Project	<b>IEEE 802.16 Broadband Wireless Access Working Group</b> < <a href="http://ieee802.org/16">http://ieee802.org/16</a> >	
Title	<b>Clean Up section 14.5.9.4-14.5.9.7</b>	
Date Submitted	<b>2006-01-1003</b>	
Source(s)	Mary Chion	mchion@ztesandiego.com
	Jeff Qian	
	Cancan Huang	
	Sean Cai	
	ZTE San Diego Inc	
Re:	Contribution on comments to IEEE 802.16g-05/008r2	
Abstract	Section clean up for 14.5.9.4-14.5.9.7.	
Purpose	Adoption	
Notice	This document has been prepared to assist IEEE 802.16. It is offered as a basis for discussion and is not binding on the contributing individual(s) or organization(s). The material in this document is subject to change in form and content after further study. The contributor(s) reserve(s) the right to add, amend or withdraw material contained herein.	
Release	The contributor grants a free, irrevocable license to the IEEE to incorporate text contained in this contribution, and any modifications thereof, in the creation of an IEEE Standards publication; to copyright in the IEEE's name any IEEE Standards publication even though it may include portions of this contribution; and at the IEEE's sole discretion to permit others to reproduce in whole o

**Figure xxx HO primitives flow between Serving BS and NCMS, BS initiated**

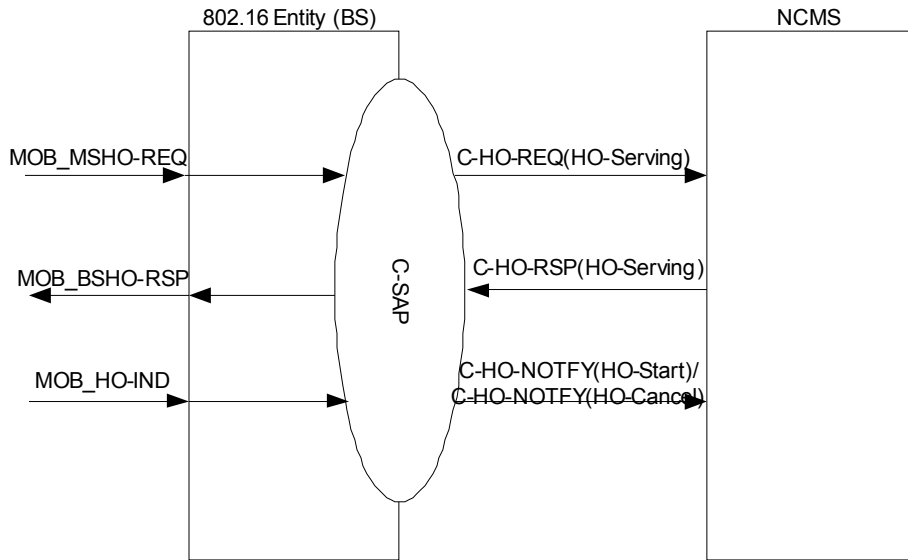
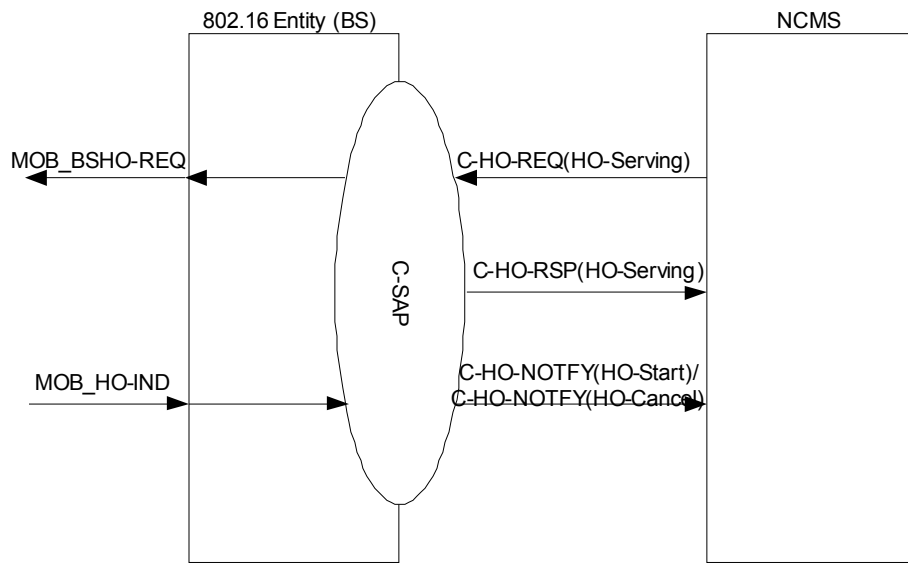
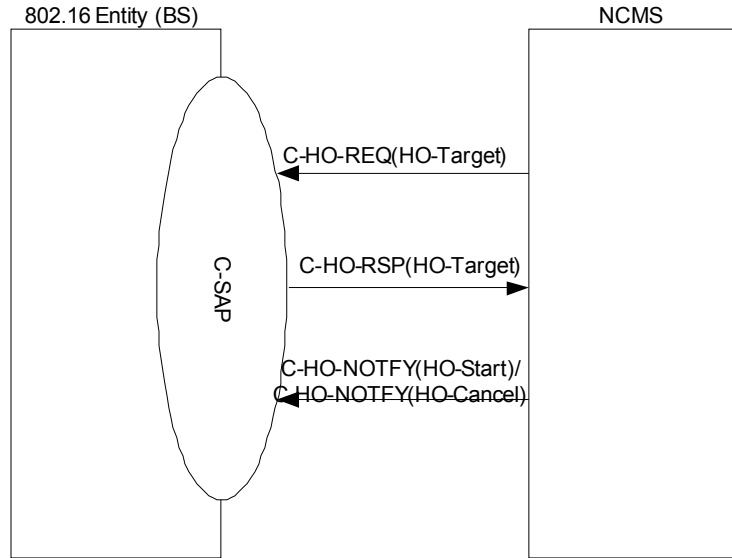
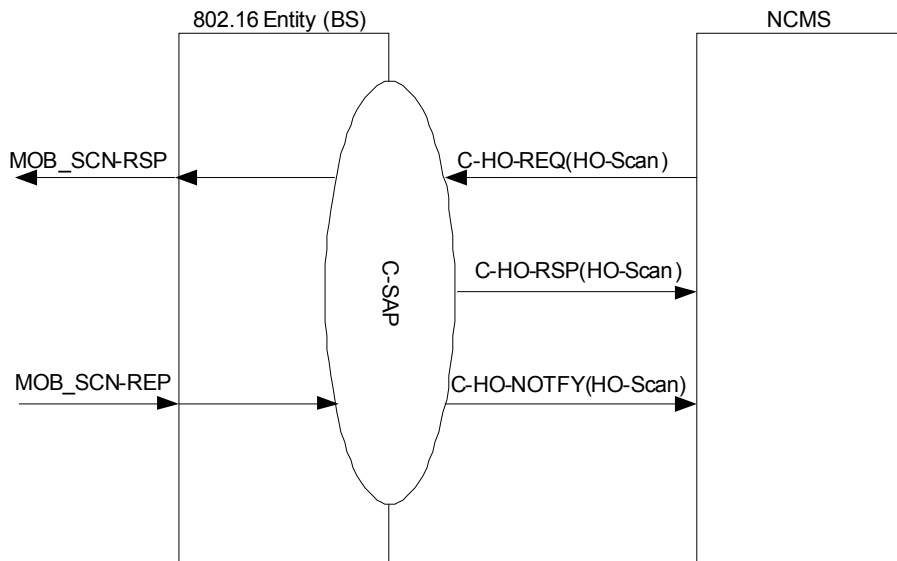
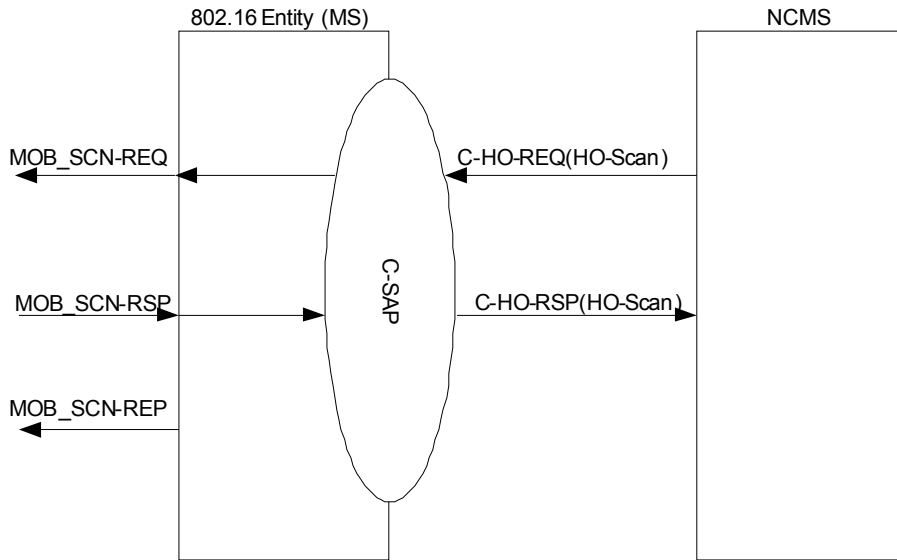
The following changes are made in section 14.5.9.4-14.9.5.7:

1. Rename Primitives. The following table provides a mapping between the old and new names of the primitives:

Existing Primitives	New Primitives
HO request (Source BS to NCMS)	C-HO-REQ(Op==Action, Action_Type==HO-Serving)
HO indication (NCMS to Target BS)	C-HO-REQ (Op==Action, Action_Type==HO-Target)
HO response (NCMS to Source BS)	C-HO-RSP(Op==Action, Action_Type==HO-Serving)
HO confirmation (Target BS to NCMS)	C-HO-RSP (Op==Action, Action_Type==HO-Target)
HO start	C-HO-NOTFY(Event_Type==HO_Start)
HO cancel	C-HO-NOTFY(Event_Type==HO_Cancel)

HO Directive (NCMS to Source BS)	C-HO-REQ(Op==Action, Action_Type==HO-Serving)
Scanning.request	C-HO-REQ(Op==Action, Action_Type==Scan)
Scanning.response	C-HO-RSP(Op==Action, Action_Type==Scan)

2. Due to the renaming and merging of some primitives, the section is re-arranged. However, the content of the primitives are kept same except for some additional fields due of adopted changes in contribution C80216g-05\_052r4.
3. Use of 802.16 Entity instead of BS. An 802.16Entity can be either a BS or MS. When a primitive is defined for both BS and MS unless specified otherwise.
4. Primitive diagrams are modified according to contribution C80216g-05\_052r4 and also the introducing of 802.16 Entity
5. Most of the text modification shown is due to re-arranging of the section. Only minor text modification is introduced.

**Figure 326—Example Primitive Flow of HO Initiated by MS**

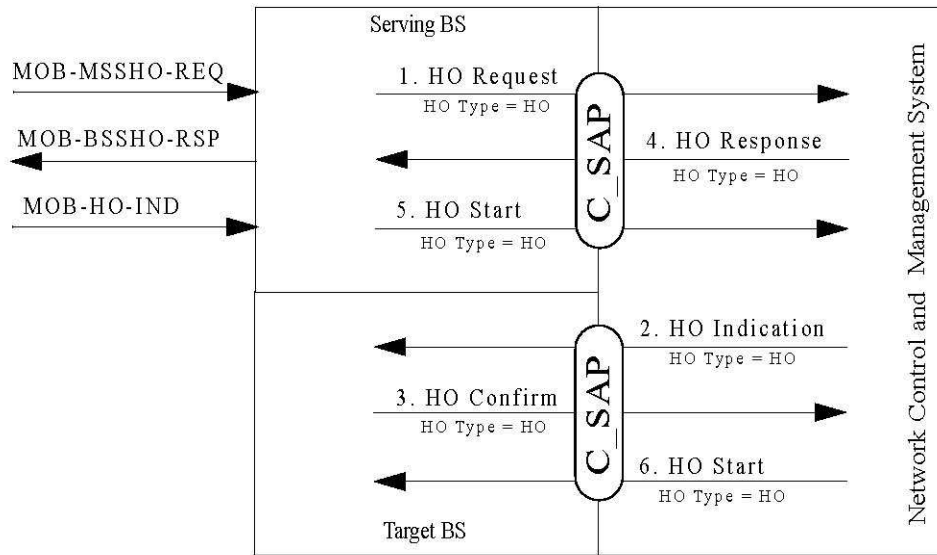
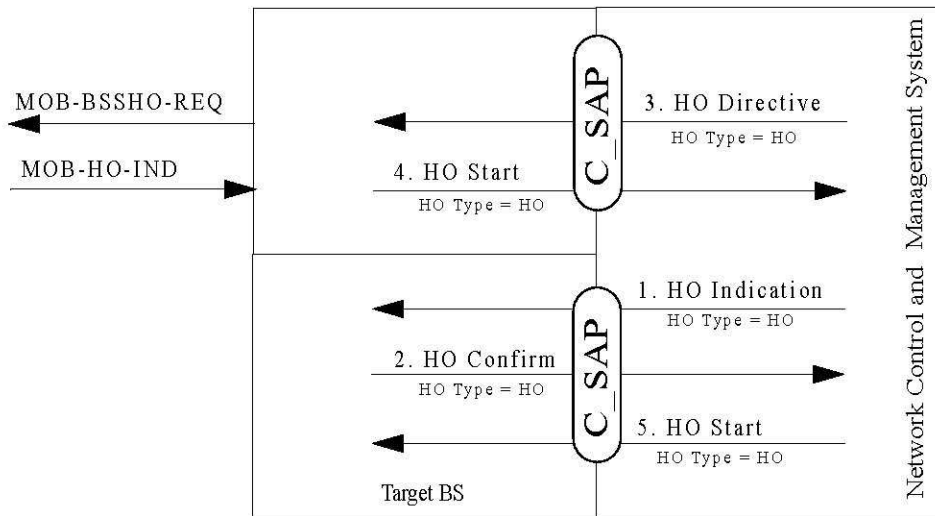
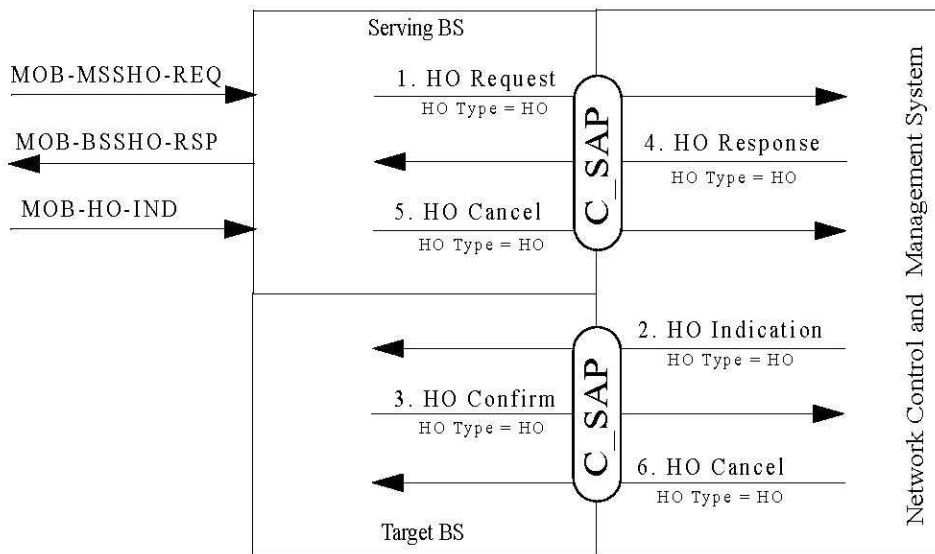
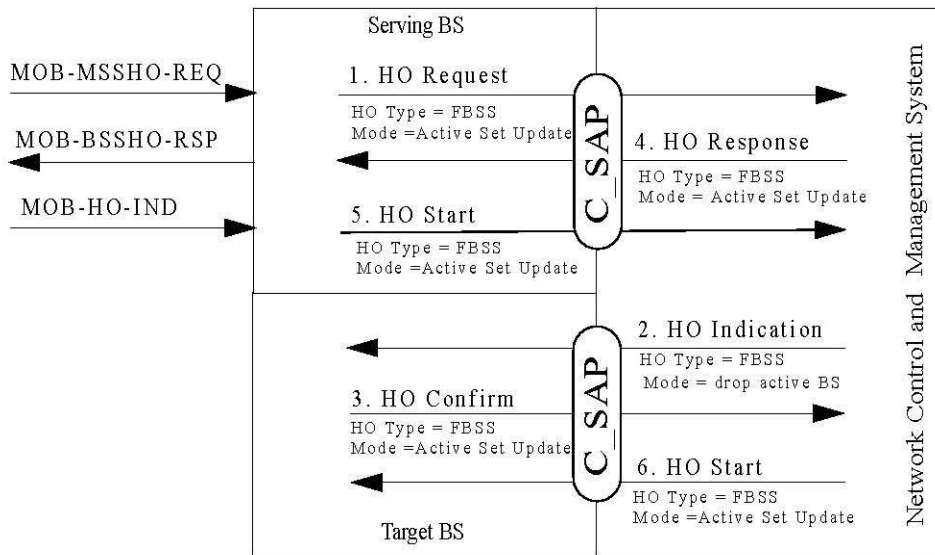
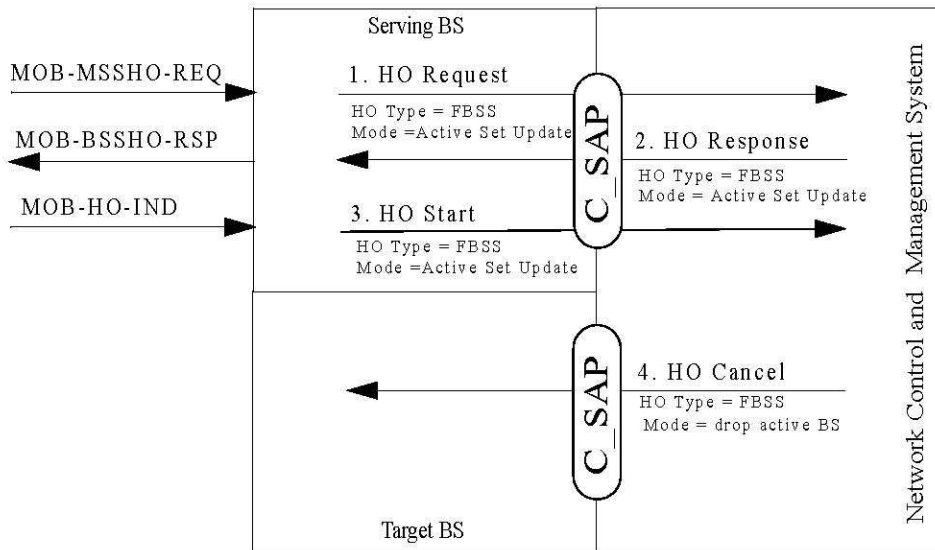
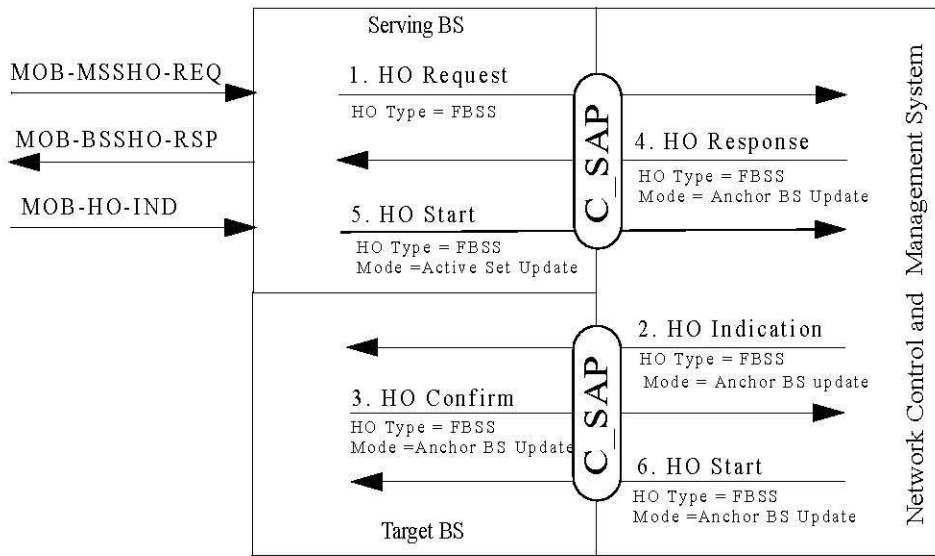
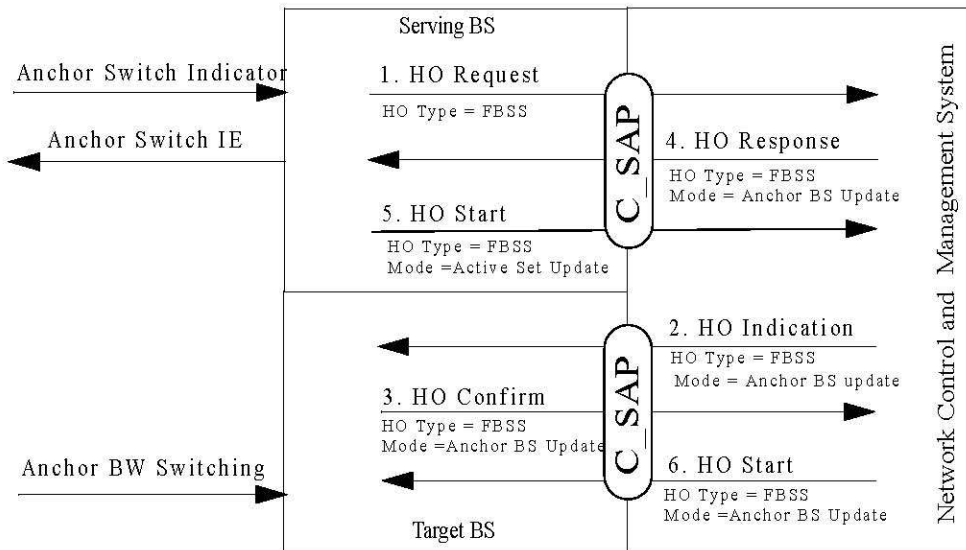
<Note to Editor: Move the following sections into Annex G>
